# UNITED STATES PATENT AND TRADEMARK OFFICE

APPLICATION NO.	FILING DATE	FIRST NAMED INVENTOR	ATTORNEY DOCKET NO.	CONFIRMATION NO.
10/679,697	10/07/2003	Choong Un Lee	054358-5017	3567
9629	7590	03/22/2005	EXAMINER	
MORGAN LEWIS & BOCKIUS LLP 1111 PENNSYLVANIA AVENUE NW WASHINGTON, DC 20004			DUONG, THOI V	
			ART UNIT	PAPER NUMBER
			2871

## Office Action Summary

## **DETAILED ACTION**

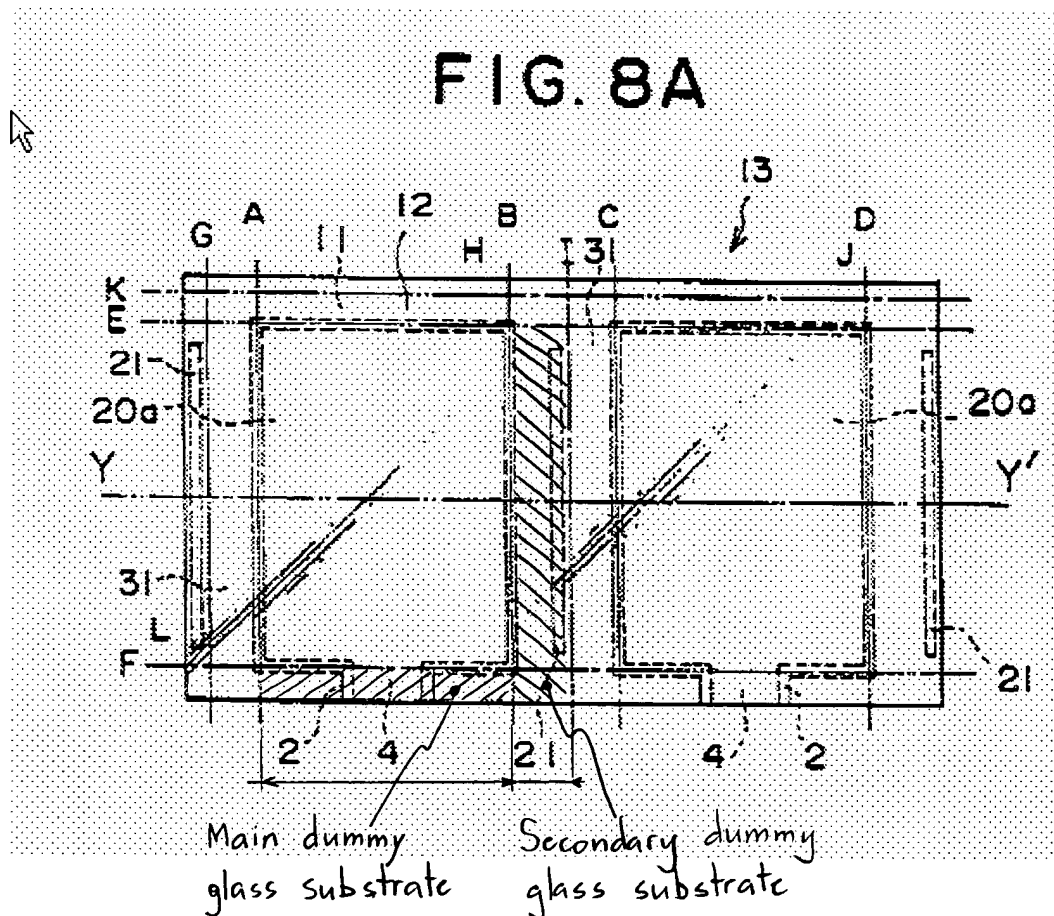
forming first and second cutting lines G-L and A-D on each of the first and second mother substrates (Figs. 7A and 7B); and

separating a plurality of first and second unit liquid crystal display panels 20a from the attached mother substrates,

wherein the attached mother substrates include main dummy glass substrates and secondary dummy glass substrates divided by the first and second cutting lines H and B, and the sealant patterns 2 are located to be extended to the first cutting lines H between the main dummy glass substrates and the secondary dummy glass substrates (see Fig. 8A below).

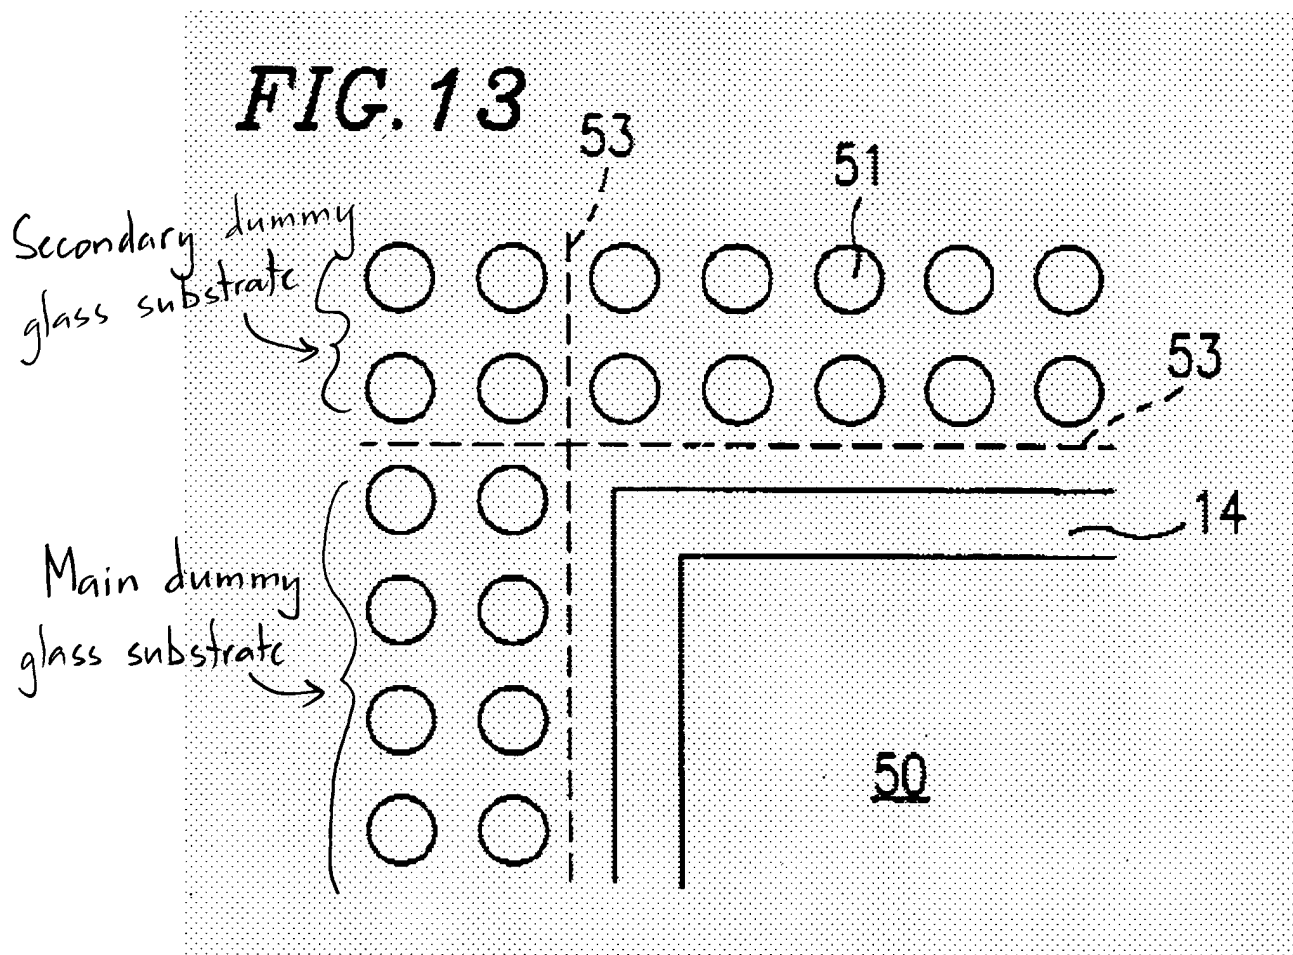
As shown in Fig. 1, Nakahara discloses that a color filter can be formed on at least one of the substrates (col. 9, lines 4-5).

Thus, it would have been obvious to one having ordinary skill in the art at the time the invention was made to modify the method of Koderia by forming a plurality of color filters on the first substrates for obtaining a color display.
